# Author’s response - The impact of far-reaching offshore cluster wakes on wind turbine fatigue loads

Arjun Anantharaman, Jörg Schneemann, Frauke Theuer, Laurent Beaudet,  
Valentin Bernard, Paul Deglaire, and Martin Kühn

Figure 1: Distribution of the  $\zeta_{\text{free}}$  parameter shown as histograms for five stability classes. The number of cluster wake cases for each stability class is indicated in brackets in the axis label.

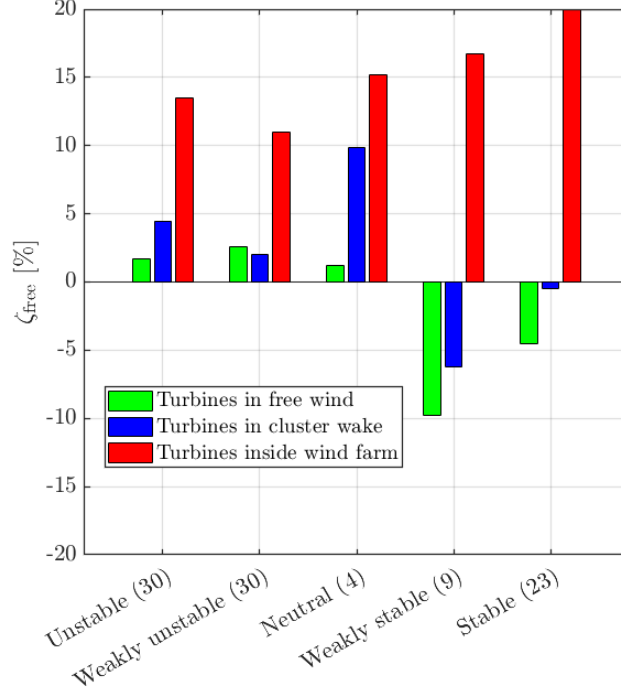
4. The conclusion that atmospheric stratification has "no impact" on loads contradicts prior studies showing stability-dependent fatigue effects. The simplified stability classification (3 regimes) and reliance on WRF-derived Monin-Obukhov lengths may oversimplify boundary layer dynamics. If possible, please re-examine stability effects using direct measurements (e.g., lidar-derived TI or temperature gradients). Consider finer stability classifications (e.g., 5–6 regimes) to capture subtle interactions between wakes and stratification.

The effect that atmospheric stratification has no impact on loads is a broad statement, and we would like to clarify as to when this is applicable. From Figure 13 (in the manuscript), across all stability classes, the cluster wake-affected turbines show higher loads than turbines in free wind. The magnitude of this increase is highest in neutral stratification (5%), but this stability class also has the lowest number of cases. We agree with the reviewer that the simplified stability regimes may simplify boundary layer dynamics. We also used finer stability regime classifications, but this significantly reduced the number of cluster wake cases in each stability class. Figure 1 shows the results obtained using finer stability classifications and Table 1 shows the calculated parameter values.

When we divided the stability classes into finer regimes as shown below, there was no trend for the increase in loads vs atmospheric stability. We agree that this results in non-conclusive stability effects of cluster wakes on loads, and so we have reformulated the conclusions to reflect the same. Despite

this, the consistent increase in the load indicator  $\zeta_{\text{free}}$  for cluster wake turbines supports our overall conclusions. We took the decision to keep the simplified three stability classification to ensure a higher number of cases within each stability regime.

“We also tried finer classifications of atmospheric stability, and did not find any noticeable differences compared to the more coarse classification presented here.”

Figure 2: (a) Standard Loads (SL) matrix for  $a'_{fa}$  in inner farm wake situations and the corresponding SEM (b), both dependent on  $u$  and  $u'$ .

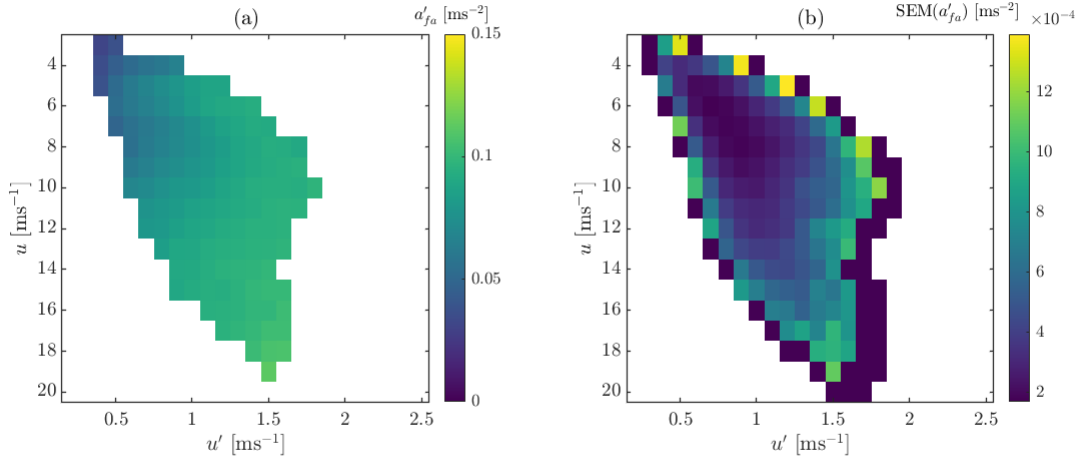
17. Page 12, Figure 7 : It would be interesting to add SL for inner farm effects even if it is not explained in detail. (but this would increase the size of the paper)

We thank the review for noticing that the SL for inner farm effects was left out. We initially did have the SL inner matrix image in the manuscript (cf. Figure 2), but we left it out as it increased the size of the paper and also did not add to the conclusions. The main performance indicator with low biases was  $\zeta_{\text{free}}$  and so we decided to leave the image of the SL for inner farm wake conditions out of the manuscript. In Fig. 2 the SEM is noticeably higher in many more of the bins as compared to SL free, which is also the reason why we stated that for inner farm wake situations, much more data is needed since the flow is very complex and directionally dependent. We added some text to address this in the methods section, also in conjunction with comments from reviewer#1.

“We also created the SL-inner table (not shown) for inner farm wake conditions and found that the SEM was much higher than SL-free, due to lower data and more complex flow dynamics due to inner farm wakes in each  $u$  and  $u'$  bin.”

Figure 3: Layout of alpha ventus, FINO1, and the surrounding wind farms including relative directions and distances. The origin is the FINO1 platform. Background layer used with permission from 4C Offshore (last access: 1 December 2020). Image taken directly from Pettas et al. [2021].

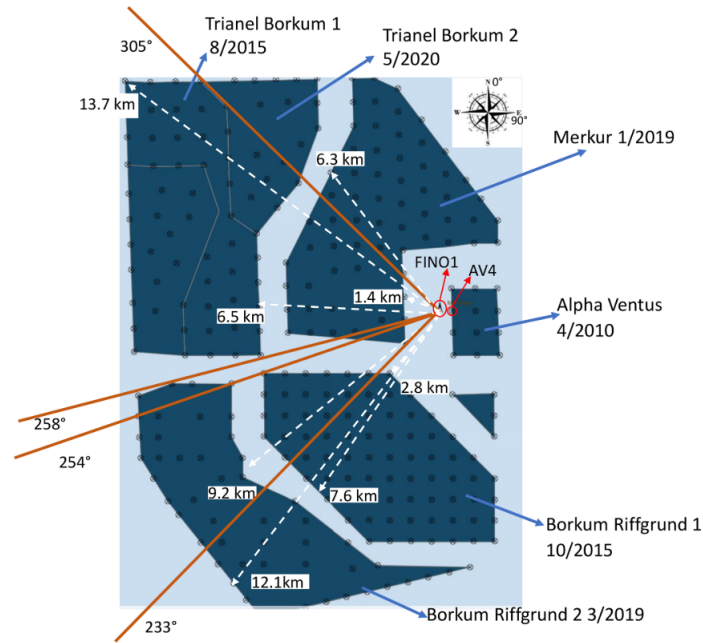
20. Page 22, line 386 : “Pettas et al. (2021) found the maximum distance that the wakes from neighbouring wind farms impacted SCADA signals was 6.5 km”. Whatever the size of the upstream wind farm? Or for one layout/situation?

In the work of Pettas (2021), they studied the effect of wind farm wakes by using a met mast and one turbine of the alpha ventus wind farm and analysing the effect of all the wind farms that were eventually built around it, at varying distances. In this sentence, the maximum effect that they could detect an effect of the neighbouring farm was 6.5 km. The wind farms are highlighted in Figure 3 taken from their publication. For the specific wind farms in question, it would be the effect of the upstream wind farm Trianel Borkum 1 (2015) on the alpha ventus wind farm, which is at a minimum distance of 6.5 km away. We added some text in the manuscript that describes the size of this wind farm and compares the scale of their study to ours. We have partially rewritten this paragraph also taking into consideration comment#21.

“The upstream wind farm in their study (Trianel Borkum 1) has 40 turbines, and a total wind farm rated power of 200 MW. We only considered this situation as a point of comparison as further cluster wake scenarios in their study had low inter-farm distances ( $< 3$  km).”

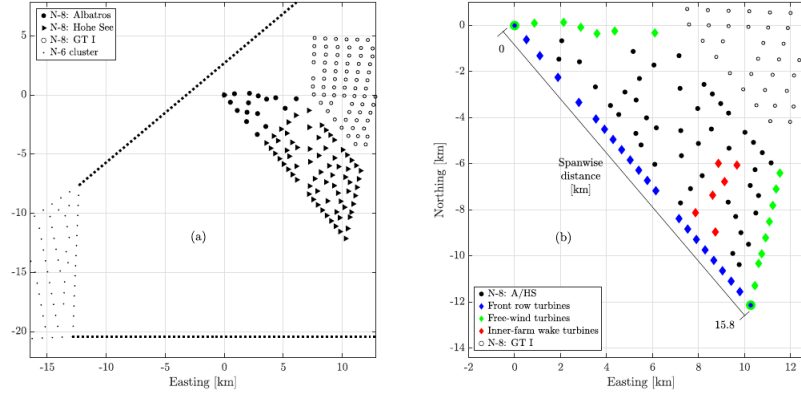
2. Page 4, line 94, Section 2.1 : “... data from the sister wind farms Albatros and Hohe See...”. The authors should also refer to Fig 2 to help to the reader locate wind farms of interest in the N8 cluster.

We agree with the reviewer that there has been no clarification on the differences in the Albatros and Hohe See wind farms in any of the presented layouts. We have now modified Figure 2(a) and differentiated between the sister wind farms and also added a clarifying note in the caption, since this demarcation is not made in the rest of the manuscript as we only refer to the combined wind farms as A/HS .

“We use operational SCADA data from the sister wind farms Albatros and Hohe See in the N-8 cluster (see Fig. 2a) in the period from...”

**Figure 13.** Bar graphs showing the performance indicators averaged over all turbines in a set for different atmospheric stability regimes, (a)  $\zeta_{\text{free}}$  and (b)  $\zeta_{\text{inner}}$ .

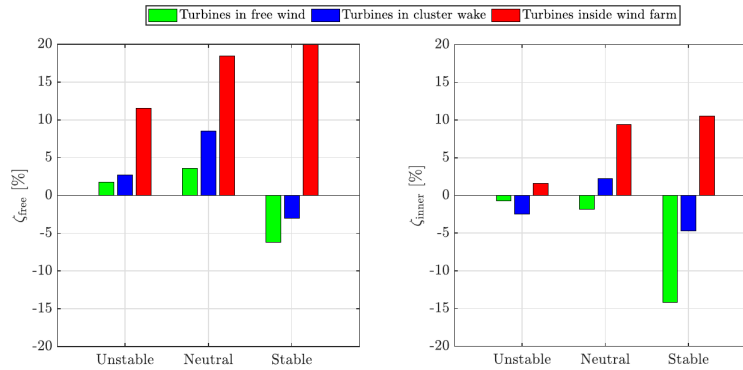
The labels for the axes were mistakenly switched, between unstable and stable stratification, the correction has been made. The paragraph describing the figure and sentences have also been corrected accordingly. The main difference is that the uncertainty (rather than the load effects) is higher in stable stratification, and this is attributed to the low number of cases within each stability class. There were also four cases which were wrongly labelled neutral, which has also been rectified. This causes the bars for neutral stratification to be very slightly different in magnitude from the earlier image. We apologize for the error in the pre-print. We would like to once again thank both the reviewers for bringing up the analysis of stability which enabled us to correct this error.
